SUBJECT: CUMBERLAND STEAM PLANT - ANNUAL ASH DISPOSAL AREA INSPECTION

SUBJECT: CUMBERLAND STEAM PLANT - ANNUAL ASH DISPOSAL AREA INSPECTION

The ash disposal area is shown on the attached print of drawing 10N212.

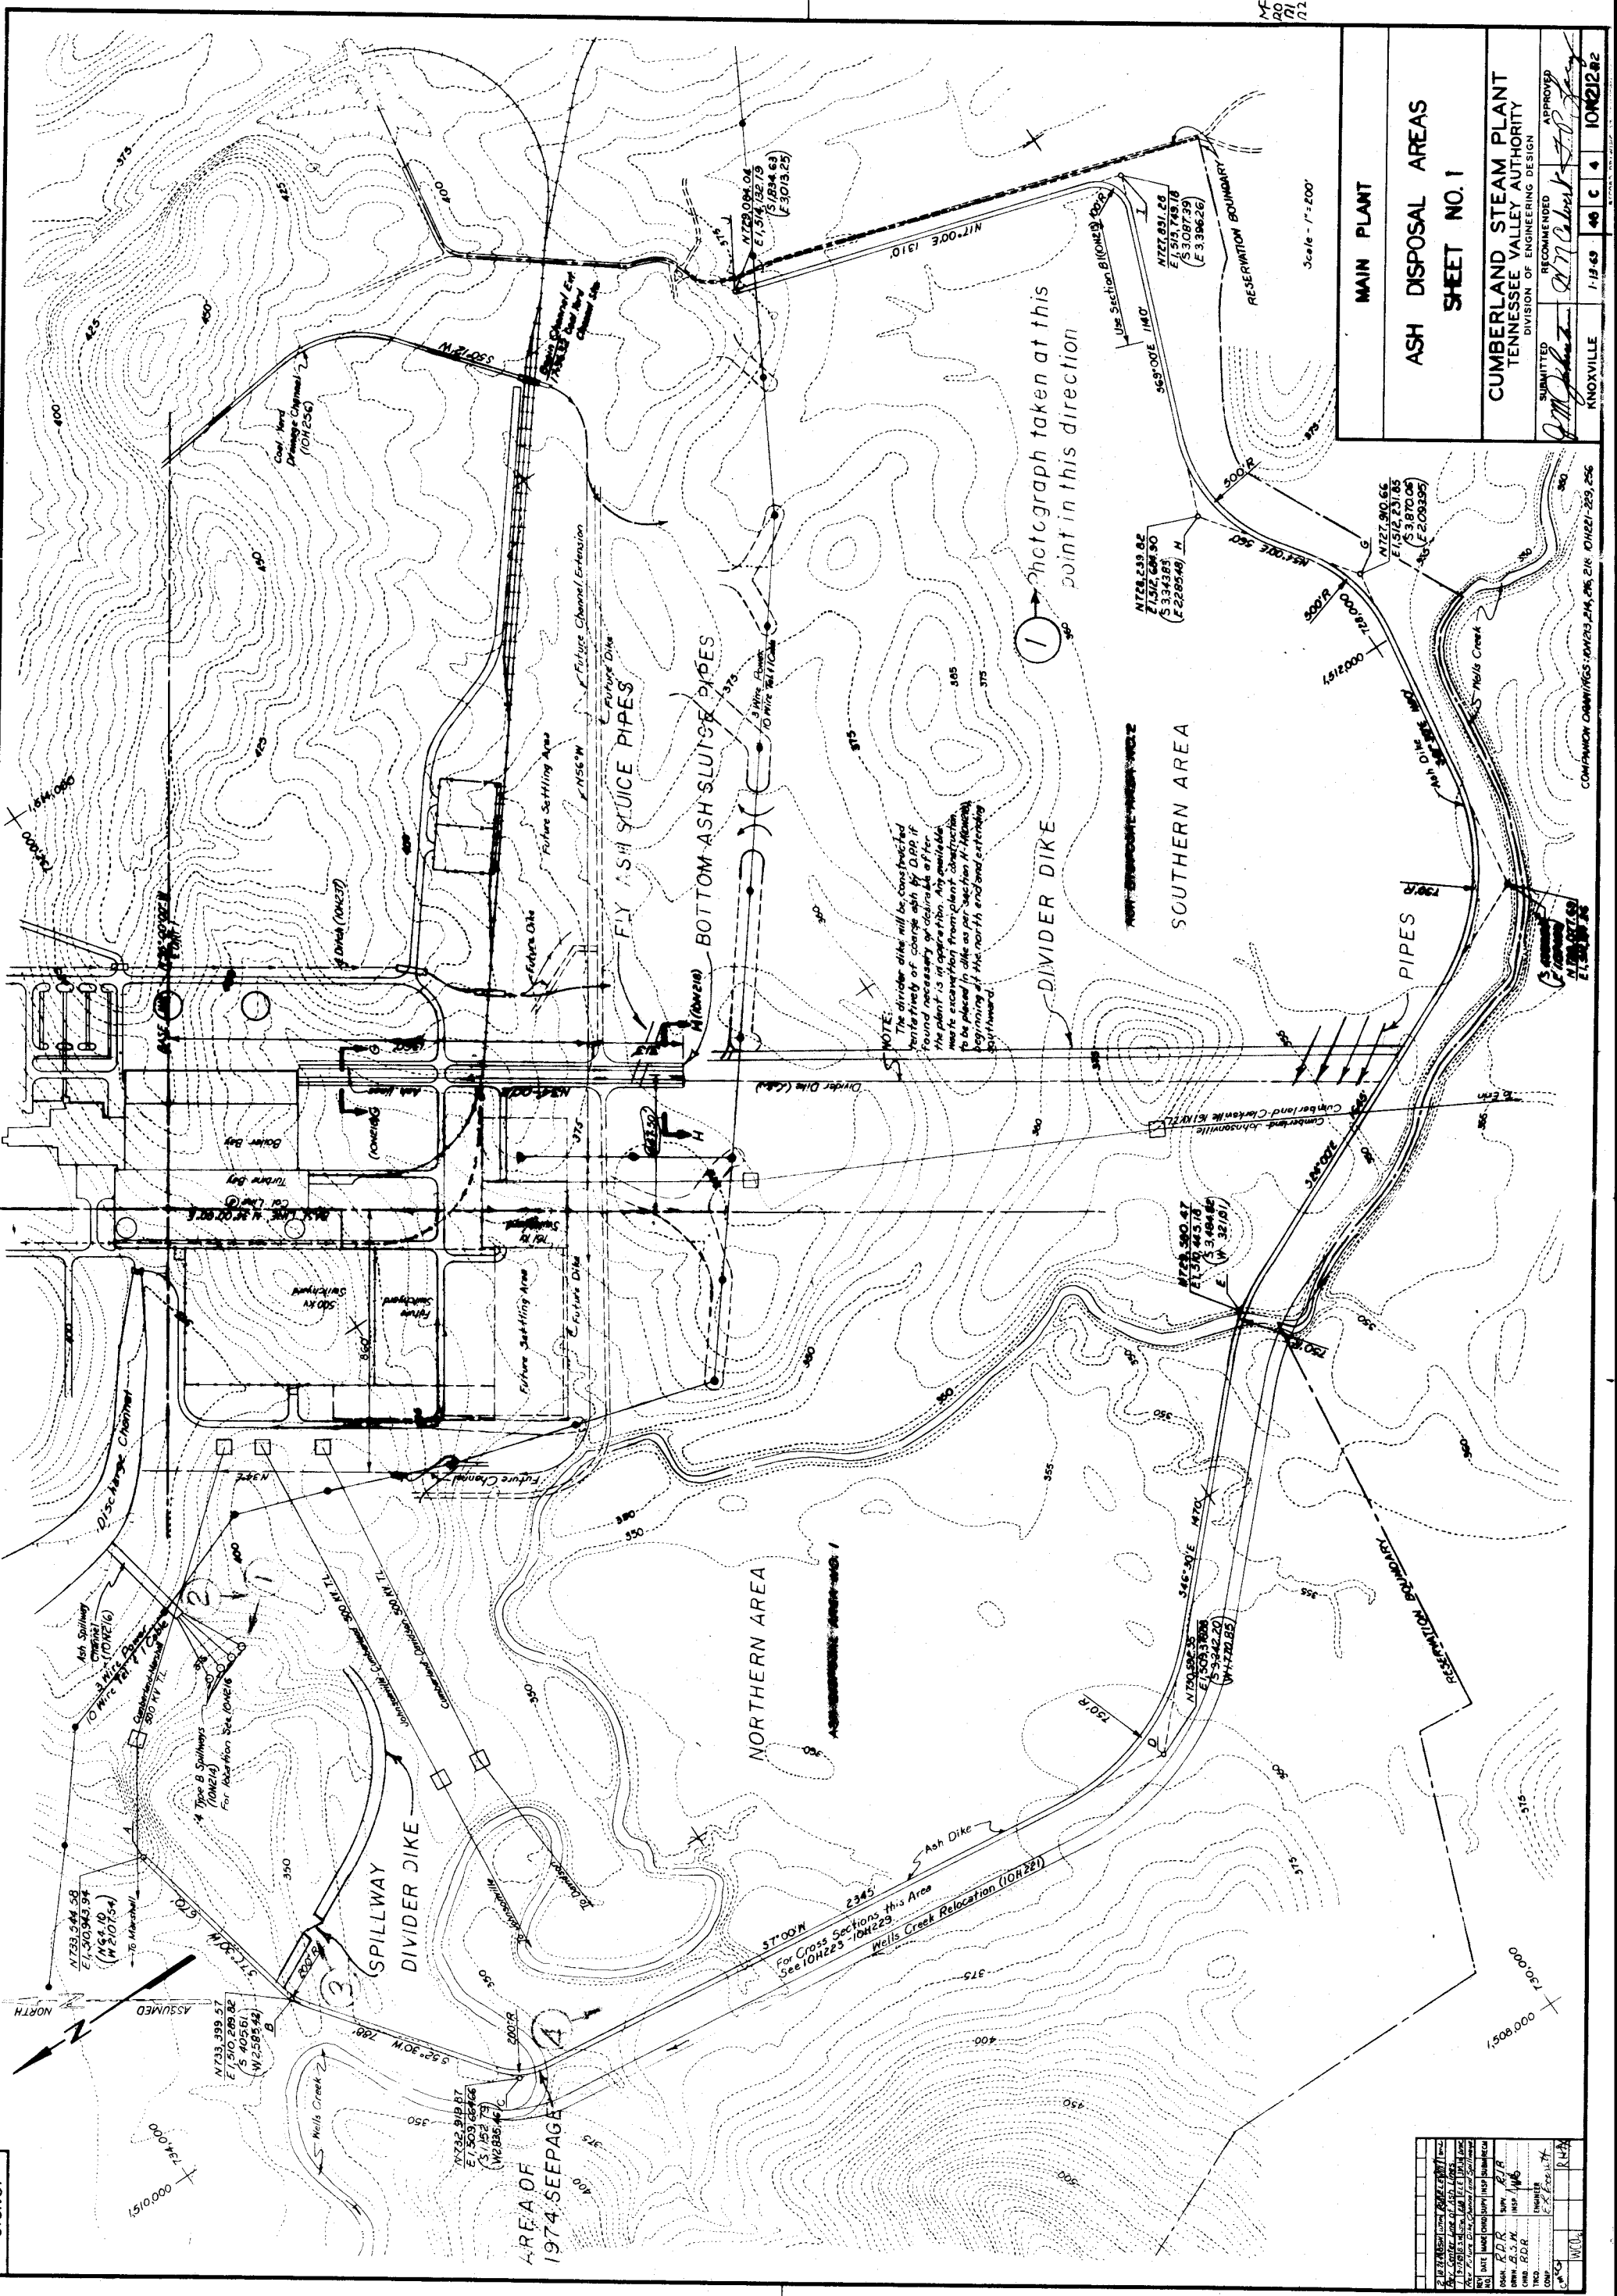
Since last year's inspection, CSB has continued construction on raising the dikes 15 feet (elevation 380 to elevation 395). CSB has raised the dikes of the southern portion (see drawing 10N212) of the pond approximately 9 feet with compacted earth. CSB has also completed lining the northern portion of the pond on the inside with bottom ash and earth spoil material and has raised the dikes of the northern portion approximately 3 feet with compacted earth. The dike has been raised the full 15 feet in the vicinity of the haul bridge across Wells Creek. Raising of the dikes has been stopped temporarily due to lack of suitable borrow material.
